Access Compliance Report

Public Rights-of-Way

Intersection ID: 12080	Main Street: E_15TH_ST	Cross Street: SEIGLE_AV	Location: W
ADA ID: DD4407A29D23	Ramp Type: Perp	Initial Pass/Fail: Pass	Overall Compliance: No
Severity Score: 30			
Codes/Mitigation Info/Possible Solution		Field Measurements/Component Compliance

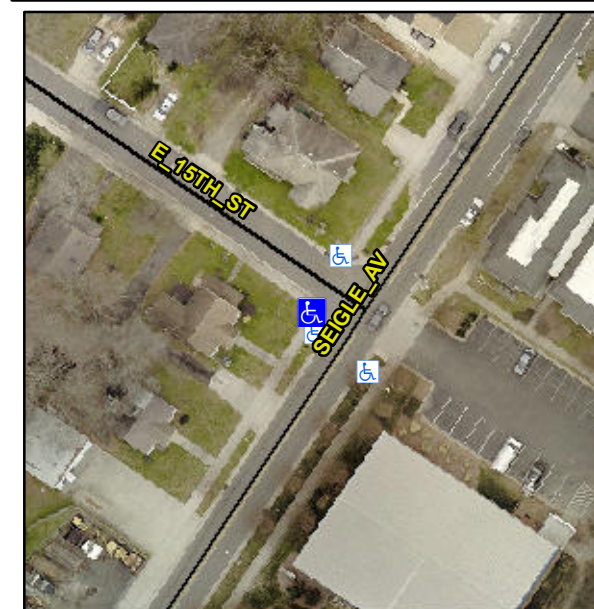
Compliance	Description	Data	Compliance	Description	Data
N/A	Ramp Length (in)	84.0	Yes	Ramp Slope (%)	5.6
Yes	Ramp Width (in)	49.0	Yes	Ramp XSlope (%)	0.6
N/A	Flare Type LT	None	N/A	Flare Type RT	N/A
N/A	Flare Slope LT (%)	N/A	Yes	Flare Slope RT (%)	6.8
N/A	Flare Traversable LT?	N/A	N/A	Flare Traversable RT?	Yes
No	Landing Length (in)	N/A	Yes	DWS Provided?	Yes
No	Landing Width (in)	N/A	Yes	DWS Contrast?	Yes
No	Landing Slope (%)	N/A	Yes	DWS Length (in)	24.5
No	Landing X Slope (%)	N/A	Yes	DWS Full Width?	Yes
N/A	Landing Curb? (Y/N)	No	Yes	DWS Offset (in)	2.0
N/A	Shared Landing?	No			
Yes	Gutter Ponding?	No	No	Gutter Slope (%)	5.2
No	Gutter Lip Ht (in)	2.5	Yes	Gutter X Slope (%)	1.5
N/A	Painted X Walk1?	No	N/A	Painted X Walk2?	N/A
	X Walk 1 Direction	To NE		X Walk 2 Direction	N/A
N/A	X Walk 1 Width (in)	N/A	N/A	X Walk 2 Width (in)	N/A
	X Walk 1 Slope (%)	0.1		X Walk 2 Slope (%)	N/A
	X Walk 1 X Slope (%)	1.6		X Walk 2 X Slope (%)	N/A

N/A	Ramp inside XWalk1?	N/A	N/A	Ramp inside XWalk2?	N/A
	Road Slope (%)	N/A	N/A	Clear Space?	Yes
	Road X Slope (%)	N/A	N/A	Clear Space to XWalk (in)	N/A
Yes	Any Obstructions?	No	Yes	Storm Grate/Utility Hazard?	No
	Obstruction Type			Storm Grate/Utility Type	
		N/A			N/A
			Yes	Surface Condition? (G/P)	Good

Install Landing. Remove & Replace Gutter.

R304.2.1, R304.2.2-Perp, R304.3.2-Para, R304.5.3, R302.7.2, R304.5.4
